9.3 Process Auxiliaries

The information in this section of the reference ABWR DCD, including all subsections, tables, and figures, is incorporated by reference with the following departures and supplements.

STD DEP 9.3-2

Figure 9.3-10 Breathing Air System Flow Diagram

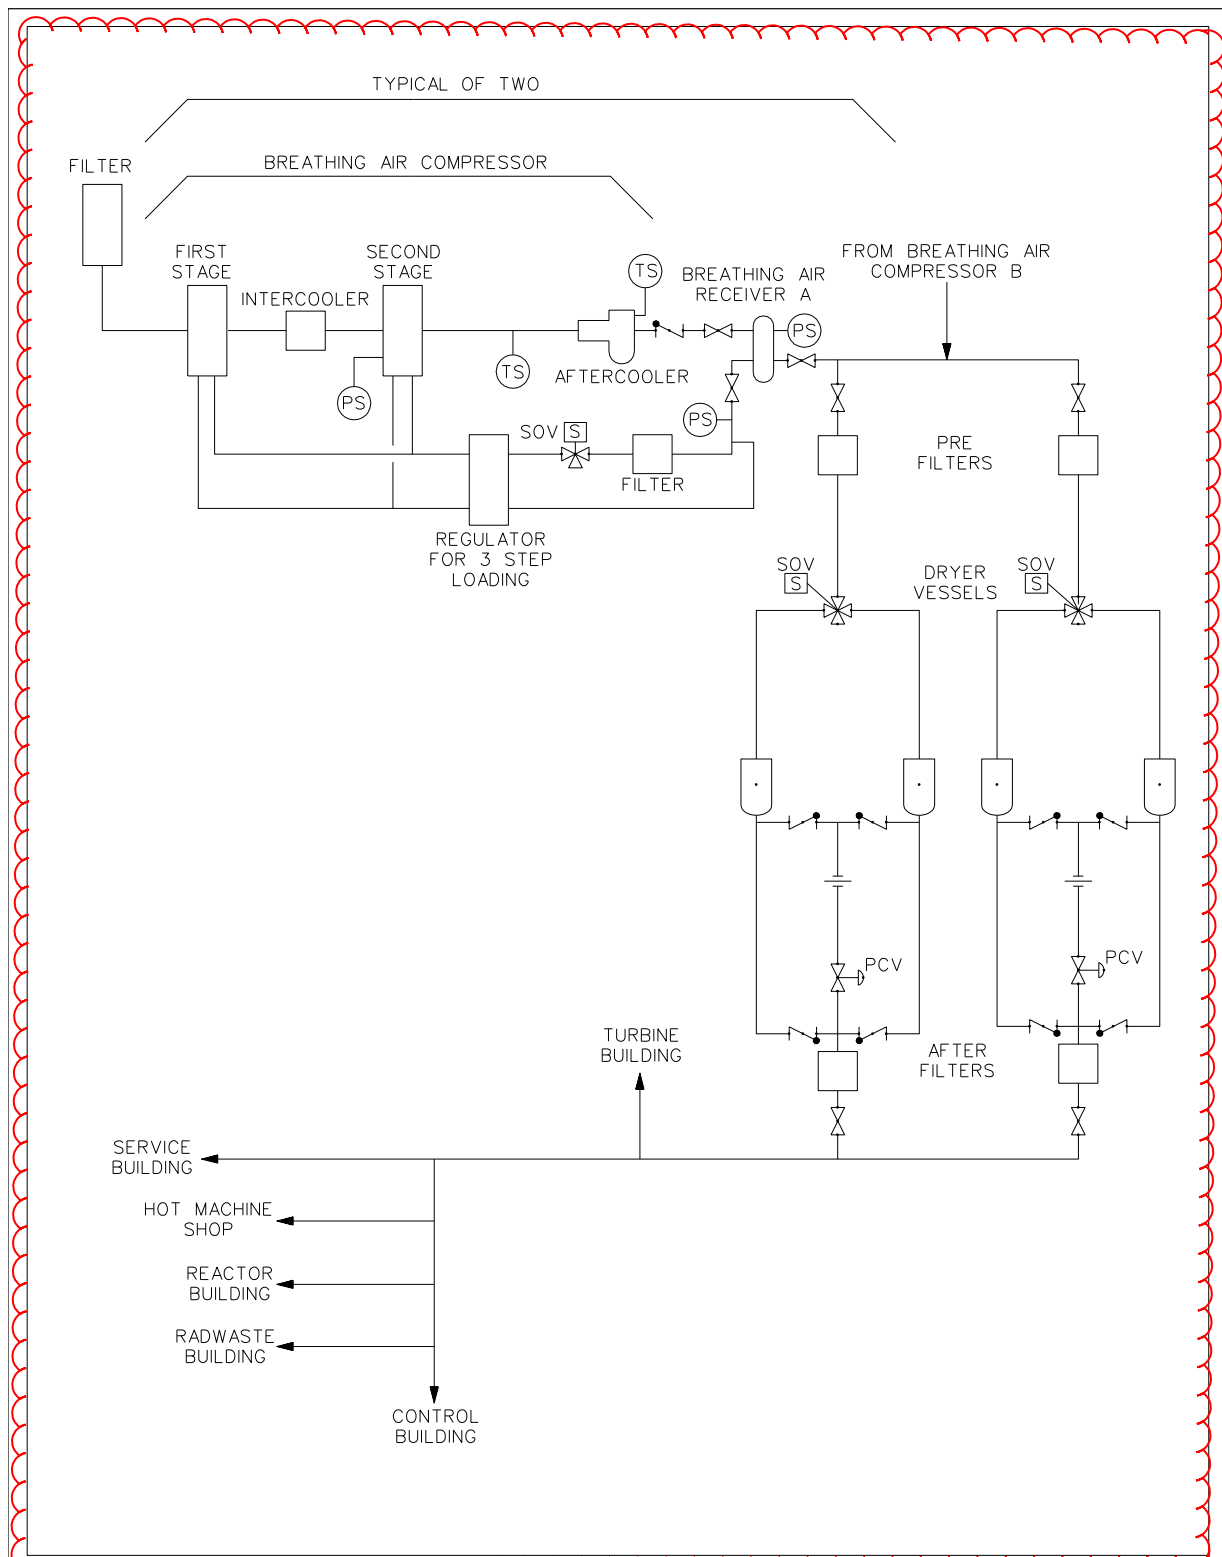
STD DEP 9.3-2

The SAS provides compressed air for tank sparging, filter/demineralizer backwashing, air-operated tools and other services requiring air of lower quality than that provided by the IAS. ~~Breathing air requirements are provided by the SAS.~~ The Breathing Air System (BAS) is discussed in Subsection 9.3.7.6.

The BAS is designed to provide compressed air of suitable breathing quality for nonsafety-related functions.

The BAS provides a continuous supply of low pressure breathing air for protection against airborne contamination while performing maintenance inspection and cleaning

work. The BAS also provides a means for charging high pressure self-contained breathing apparatus.

The BAS has two air compressors, each sized to provide 50% of the peak air consumption. The compressors are of the oil-less, breathing air type.

The BAS also has one compressor sized to charge high pressure self-contained breathing apparatus.

The BAS flow diagram is shown in Figure 9.3-10.

Outside primary containment a manually-operated valve is kept closed and locked during normal plant operation. During refueling, the valve is opened to provide air inside the containment. A check valve is provided inside the containment. This arrangement meets GDC 56, Option (2).

Figure 9.3-12 Non-Radioactive Drainage System

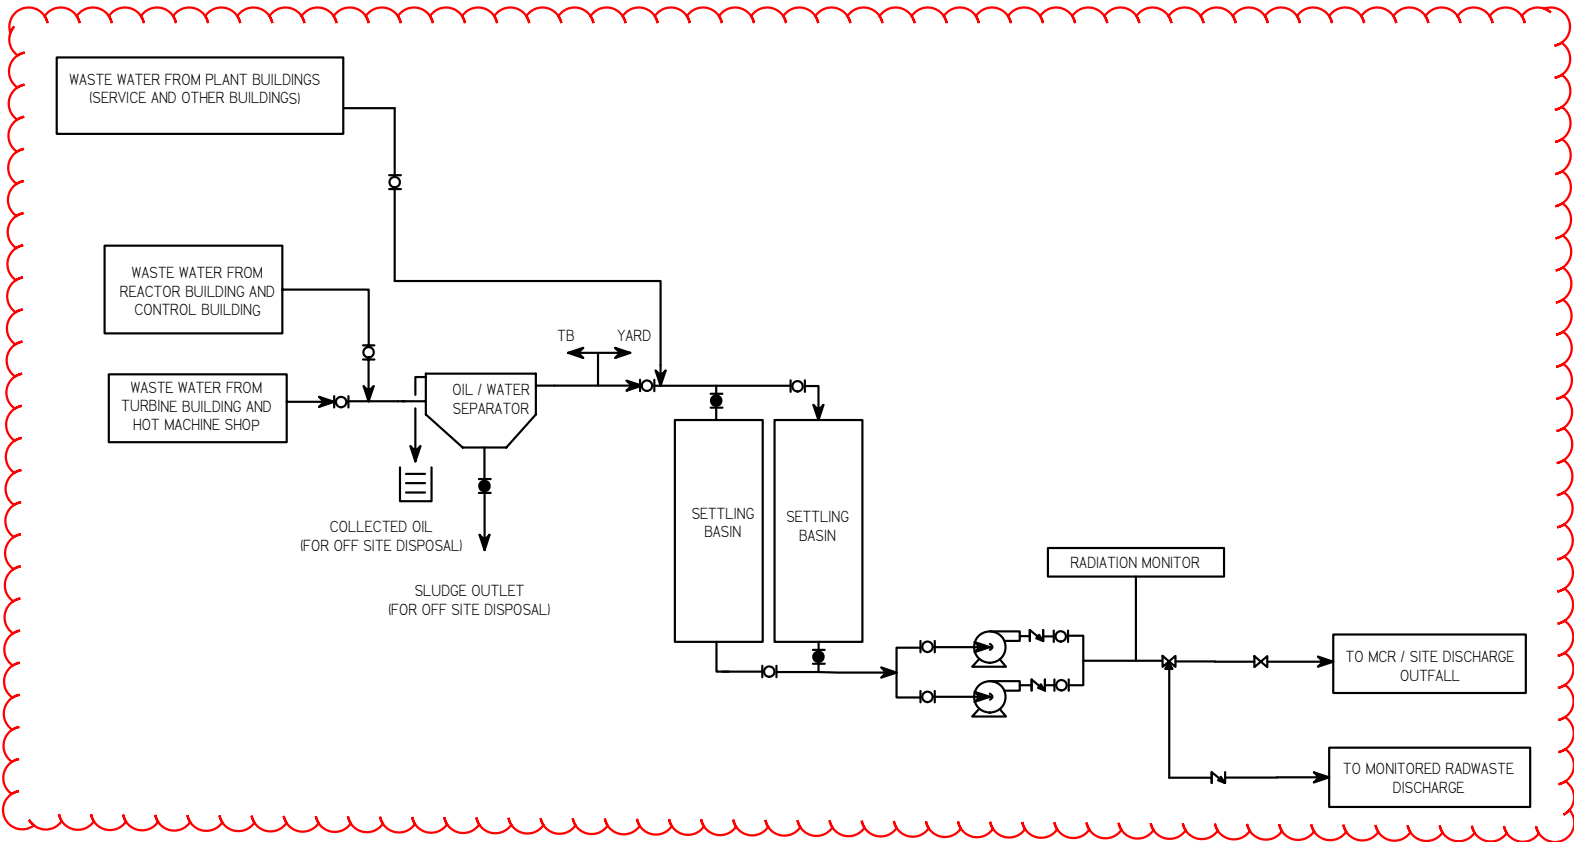
The following site-specific supplement addresses COL License Information Item 9.15.

The design of the continuation of the non-radioactive drain system from the ABWR Standard Plant Buildings to the site discharge outfall is provided in Figure 9.3-12 and is discussed in this subsection.

The conceptual design information in this subsection of the reference ABWR DCD is replaced with the following site-specific supplement.

The non-radioactive drain system collects waste water from plant buildings (Reactor, Turbine, Control, Service, and other buildings). A system composed of collection piping, curbs, and pumps is provided. Non-radioactive waste water from the Turbine Building, Reactor Building, hot machine shop and the Control Building is routed to a dedicated oil/water separator where oil and settled solids are removed for off-site disposal. The non-oily, non-radioactive effluent is sent to dual settling basins. Non-radioactive waste water from the Service Building and other buildings is sent directly to the dual settling basins. Means are provided to perform any required tests or analyses required by the discharge permit. The non-radioactive liquid effluent is discharged to the Main Cooling Reservoir through permitted outfall(s). If radioactivity levels exceed the limits for discharge, the flow from the non-radioactive drains has the capability to be diverted to the radioactive effluent portion of the radwaste system. Normally, if low levels of radioactivity are detected, it is quantified and discharged via the normal outfall. Higher levels of radioactivity may require a permitted "batch"

discharge via the radwaste effluent radiation monitor. The non-radioactive drainage system is illustrated in Figure 9.3-12.
